Corrigendum to the proposed 03 series of amendments to Regulation No. 96

Document ECE/TRANS/WP.29/GRPE/2011/11 - (European Commission) Proposal for draft 03 series of amendments to Regulation No. 96 has been introduced for consideration at the 62nd session of GRPE in June 2011. After the submission of this official document in March 2011, some editorial errors have been identified, which should be corrected without delaying the process of adoption of the proposed 03 series of amendments to Regulation No. 96.

“**Model A**
(See paragraph 4.4. of this Regulation)

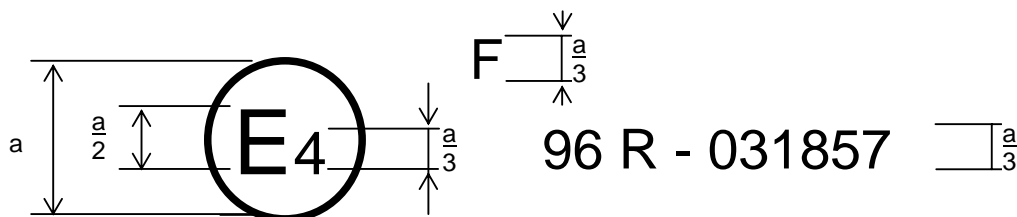
Annex 3, model A and B, correct to read:

The above approval mark affixed to an engine shows that the engine type concerned has been approved in the Netherlands (E4) pursuant to Regulation No. 96 (according to the level

corresponding to power band F) and under approval number **031857**. The first two digits of the approval number indicate that Regulation No. 96 was in its amended form (**03** series of amendments) when the approval was granted.

Justification: The provisions for approval marks have to be updated according to the new 03 series of amendments to Regulation No. 96.

Model B

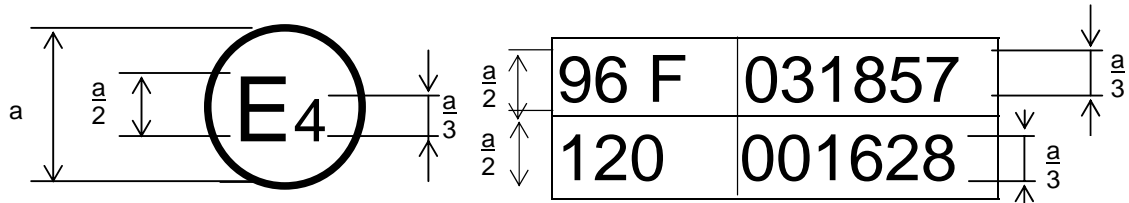
The above approval mark affixed to an engine shows that the engine type concerned has been approved in the Netherlands (E4) pursuant to Regulations Nos. 96 (according to the level corresponding to power band F) and 120. The first two digits of the approval number indicate that, at the dates when the respective approvals were granted, **Regulation No. 96 was in its amended form (03 series of amendments) and 120 in its original version.**
